SERVICE TECHNICAL INFORMATION

ONE POINT REPAIR

REF. NO.: SI-97-059

MODEL S : XR-AKH100, NSX-KH9, AKH8

E CD MAIN C.B

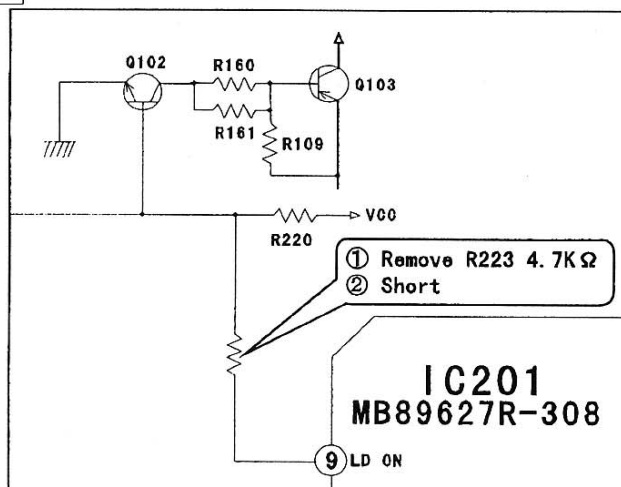
SUBJECT : The laser pickup is always on.

DESCRIPTION : During the CD function, it is found that the laser pickup is always on regardless of CD STOP.

- REMEDIES : 1) Remove R223 shown in the circuit diagrams (CD MAIN C.B) indicated below.
- 2) Short the patterns on both sides of R223.
